## CHAPTER 2 PROPOSED ACTION

### 2.1 PROPOSED ACTION

Figure 2.6-1: ~~Approximate Tritium Distribution throughout the Reactor System~~ Not Used

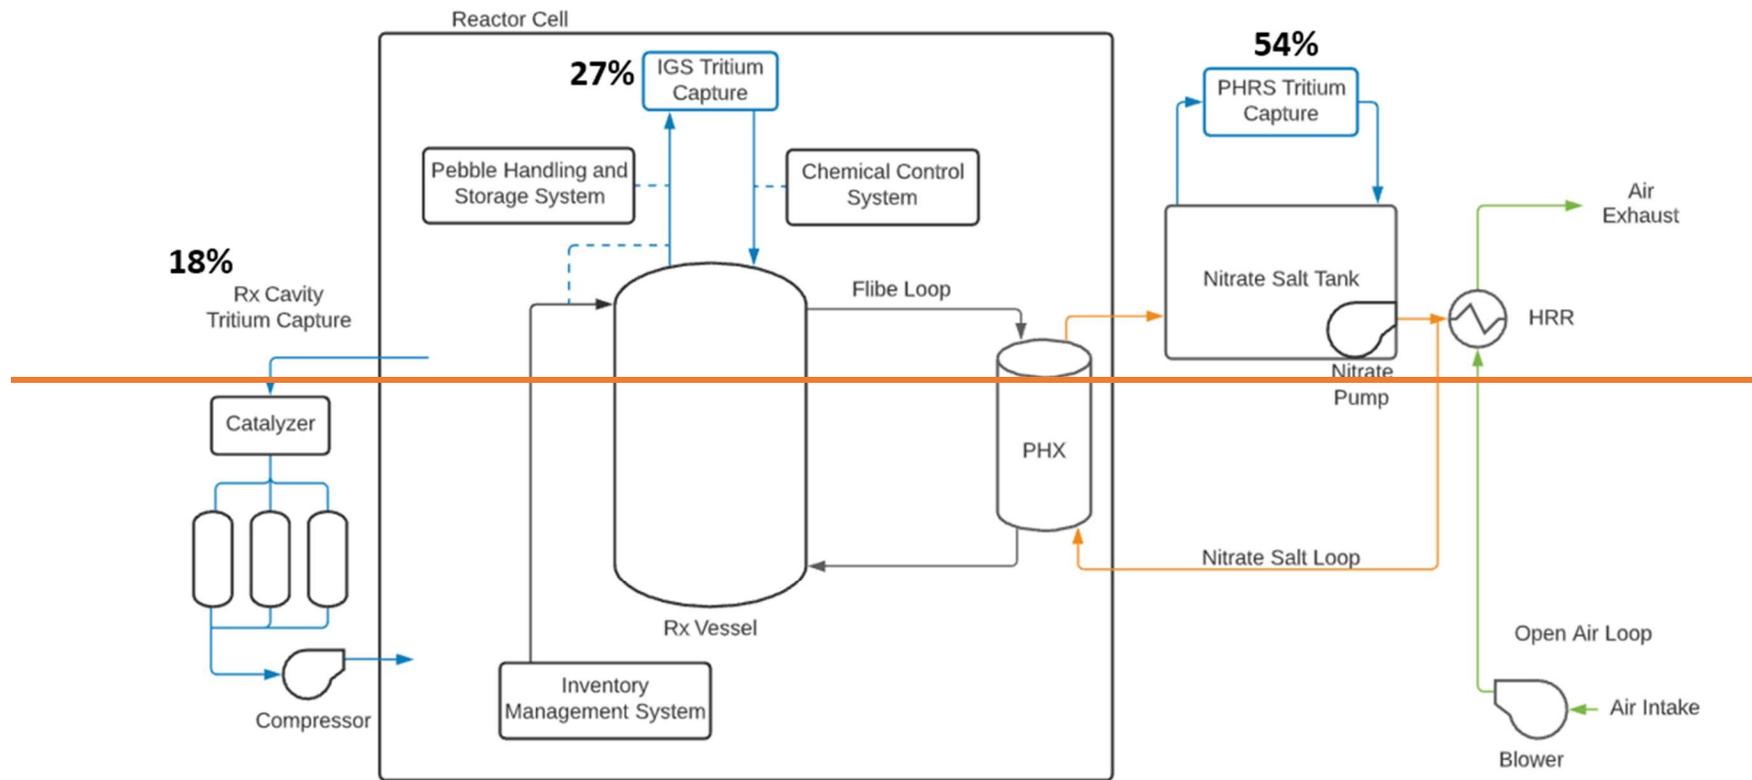
The tritium management system (TMS) would provide capture of tritium (H-3) from gas streams in various plant locations to reduce environmental releases. ~~Figure 2.6-1 identifies the tritium management system components and indicates the approximate distribution of tritium throughout the reactor system.~~ H-3 is produced primarily by neutron irradiation of lithium in the salt coolant, such as from lithium-7 (Li-7), lithium-6 (Li-6) remaining after initial enrichment, and Li-6 produced from transmutation of beryllium-9 (Be-9). The primary system functions of the TMS include:
